Project Name Choctaw Point Container Terminal – Phase V Dock Extension

ADDENDUM NO. 5

**11411- Task 6 – Choctaw Point Container Terminal – Phase V Dock
Extension
Contractor Questions
Addendum No. 5**

PROJECT NO: **4617** DWG NO: **E3** REV: **B**

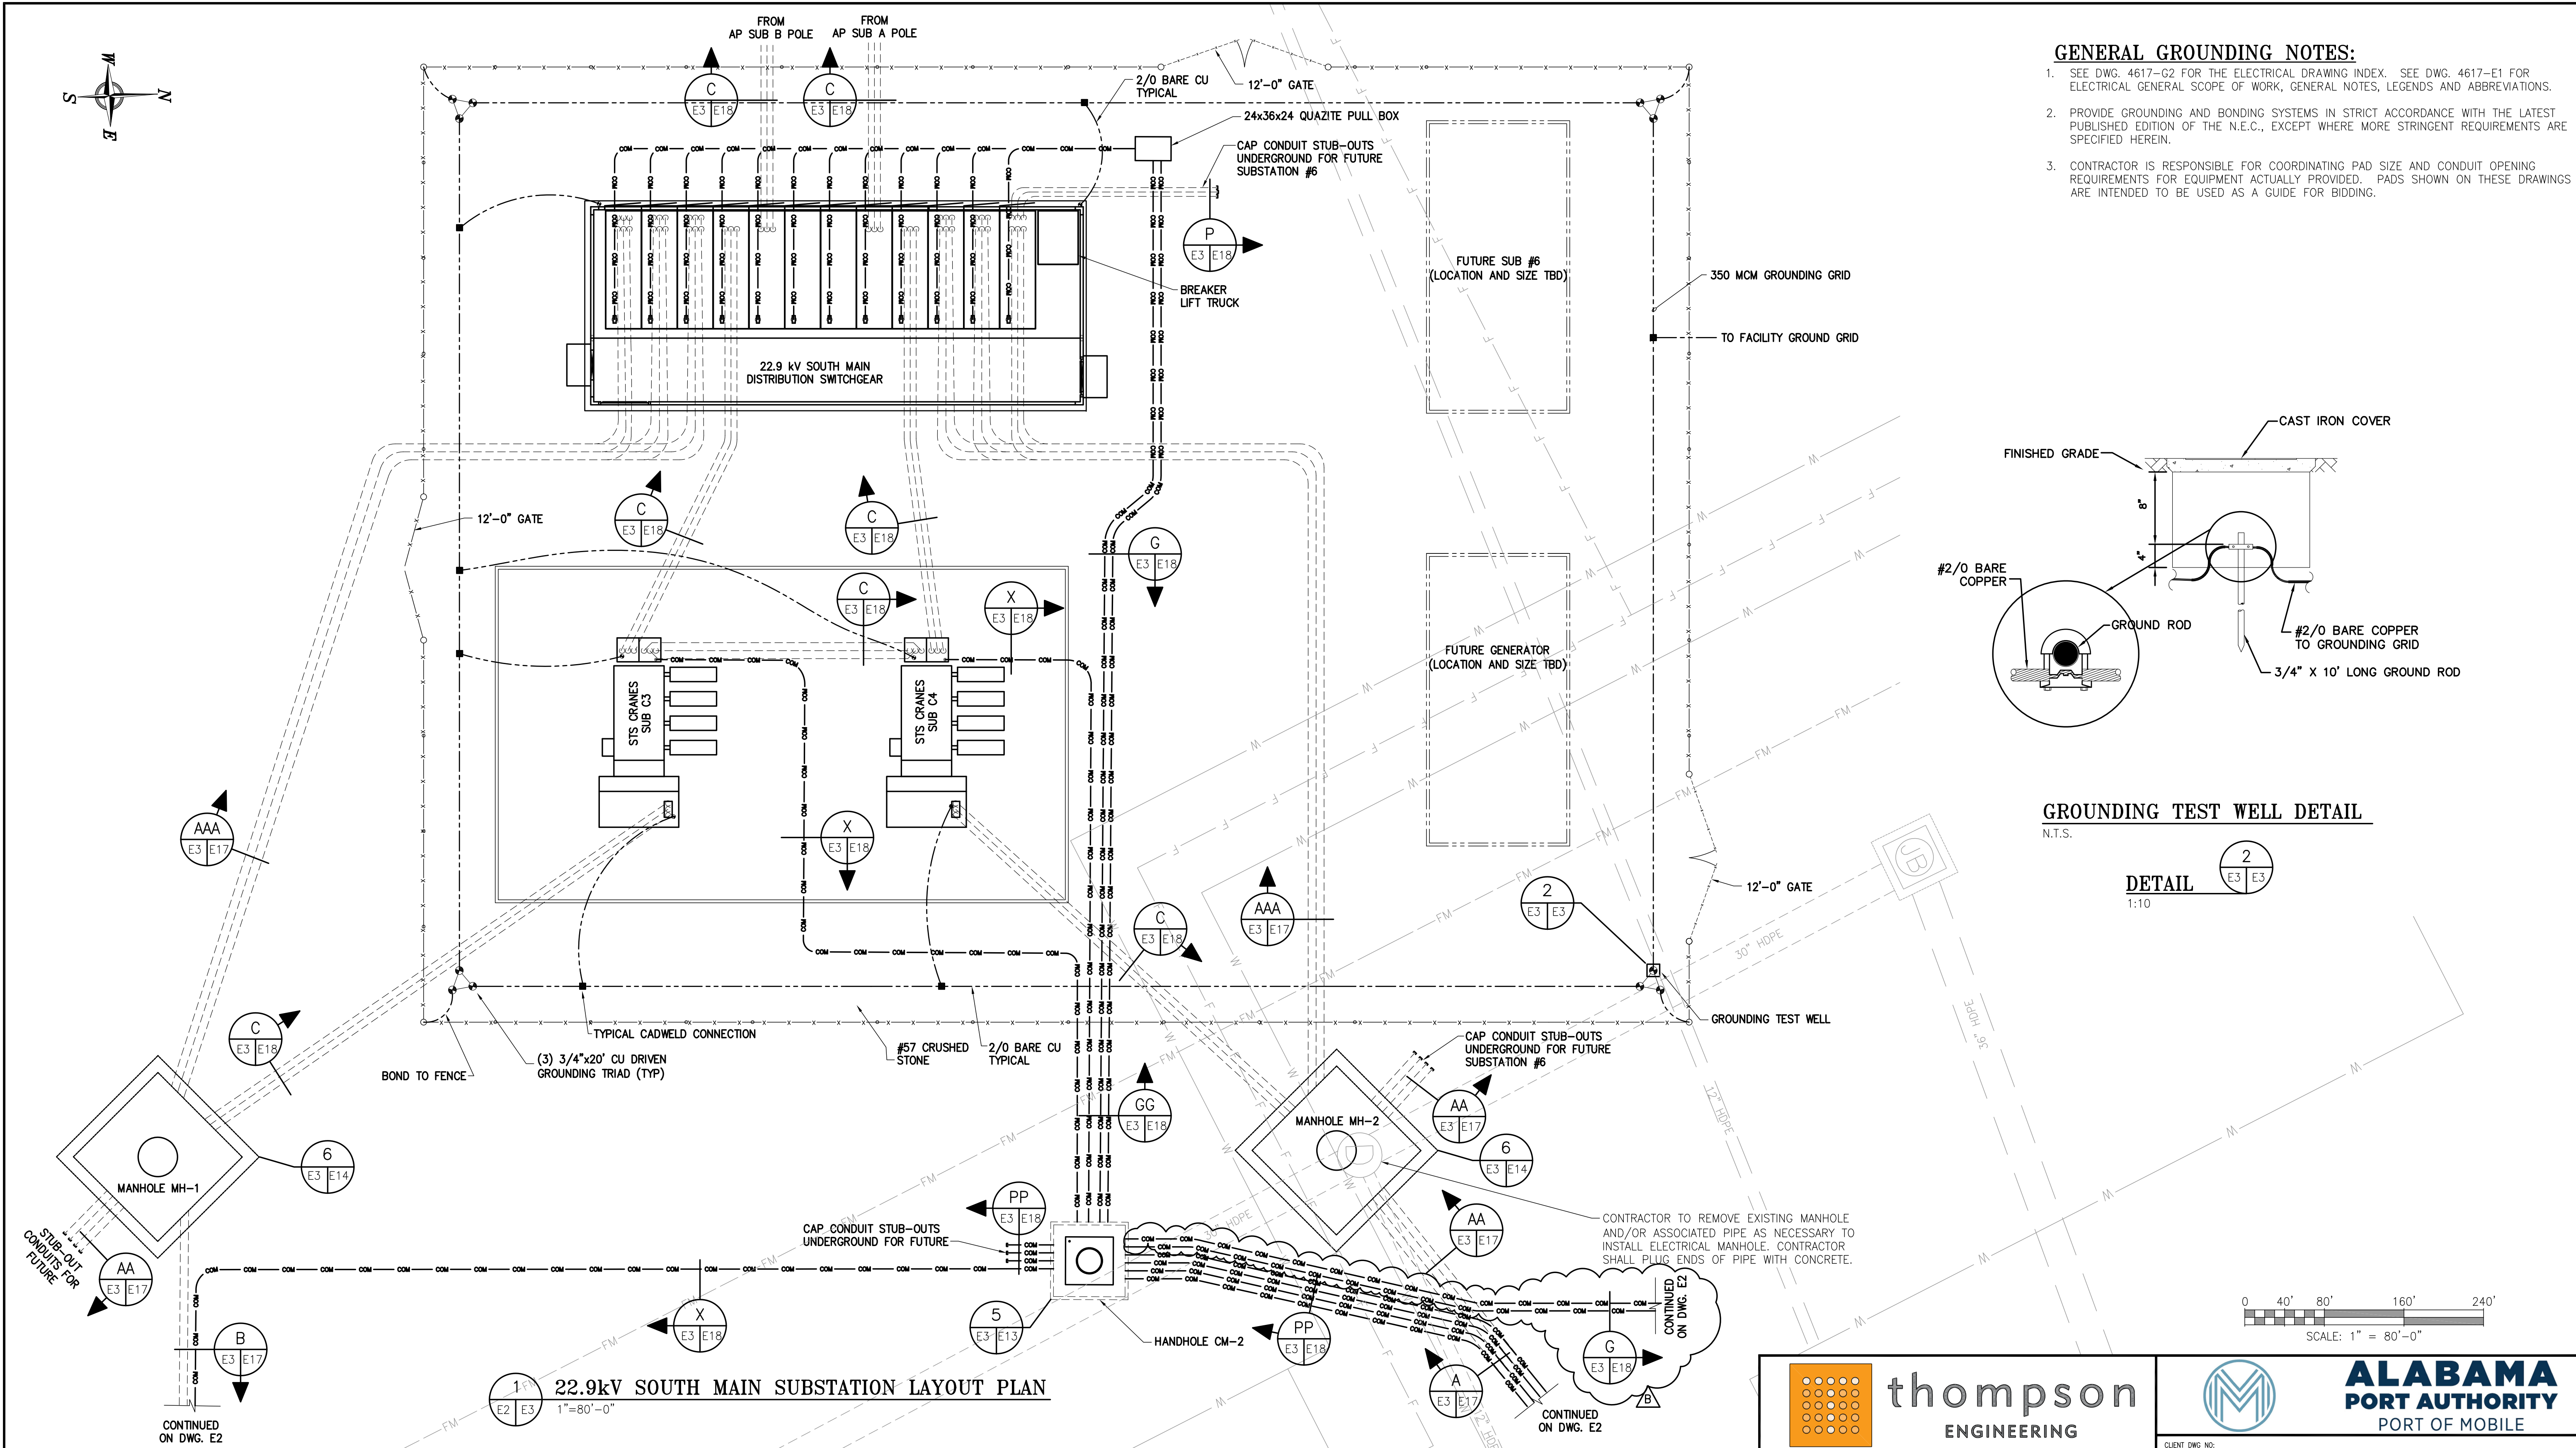
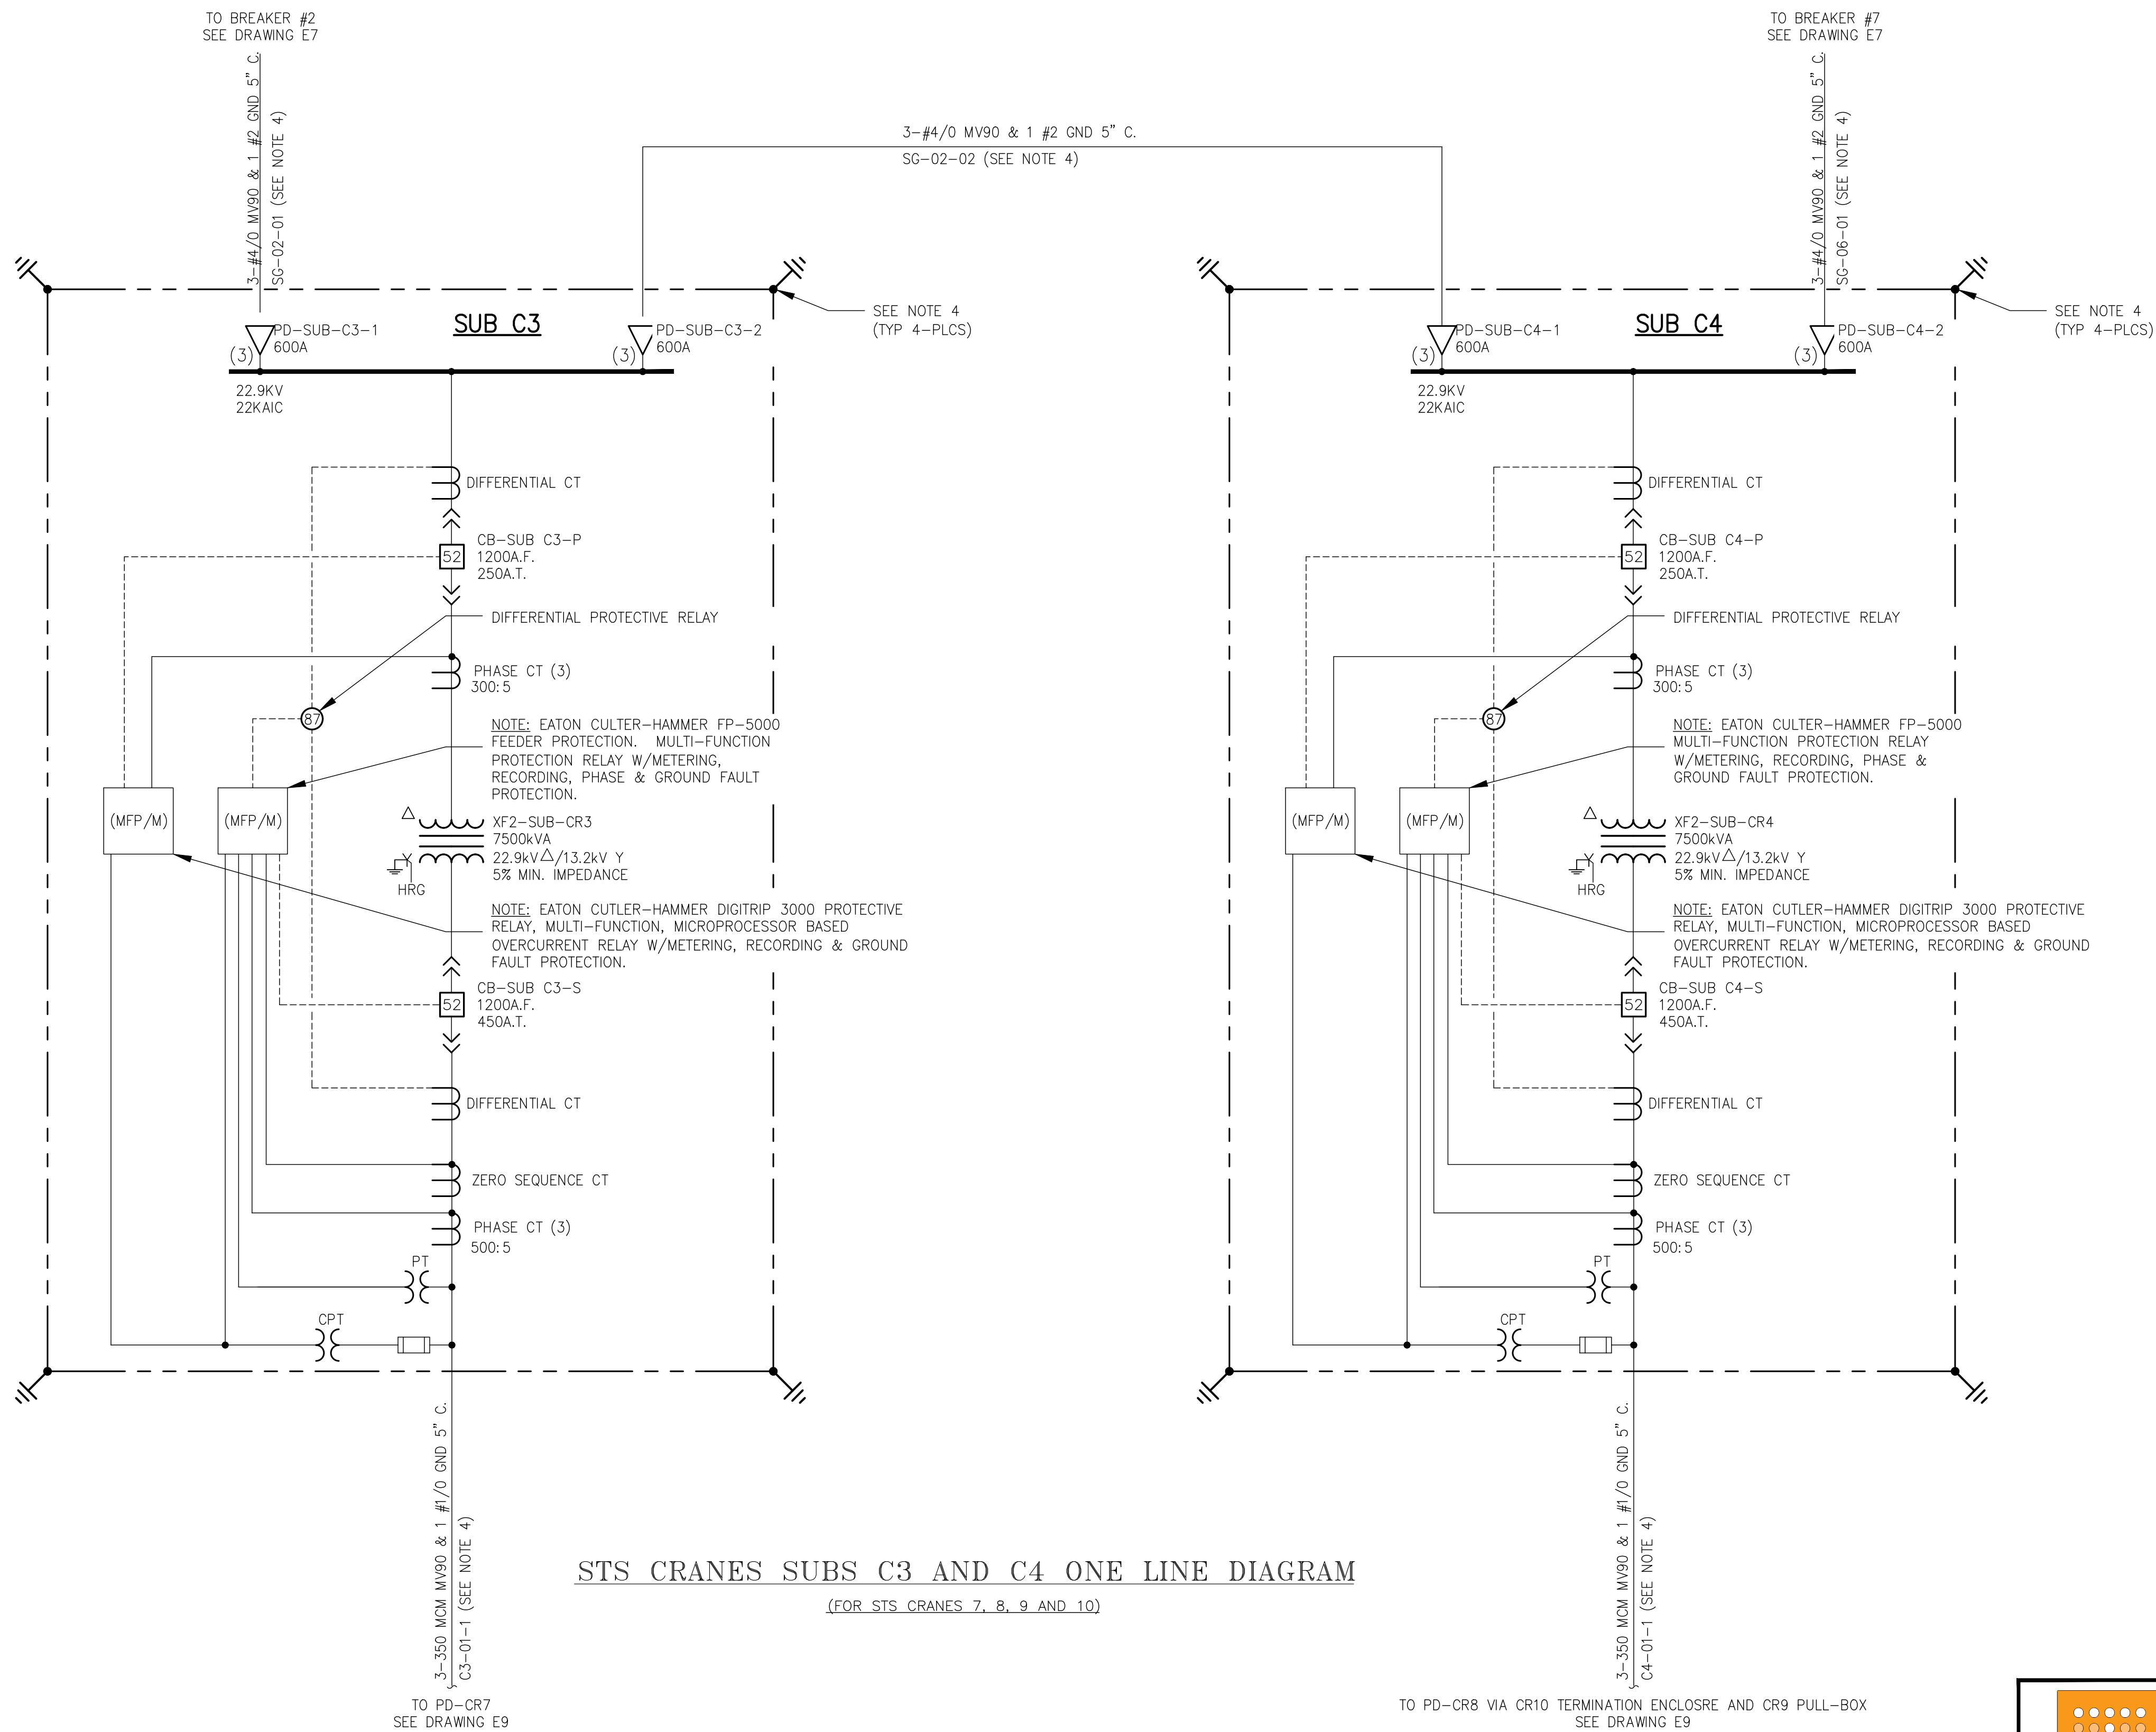
- Bid per the drawings and specifications.
6. For the 22.9kV south main substation are there two (2) or three (3) 12' gates? Drawing 4617-E3 shows three and drawing 4617-E5 shows two. Please clarify.

16. Note 6 on drawing E1 states that we are to core drill in existing communications manholes for new fiber optic conduit and cable. What drawing shows this new route and the existing manholes we have to tie into?

- Two (2) 12' gates are required.
7. Drawing 4617-BG7: Are the 3 EA 42"Ø RFP class V pipe culverts (each 148'L) shown at outfall No. 1 to be installed at 148'L per run or are they to be stubbed out/plugged from the combi-wall stem as shown on drawing 4617-S51?

- Refer to revised electrical drawings E2 and E3 included in this addendum which indicates core drilling the existing MH-30 and installing a new underground duct bank to new CM-2.
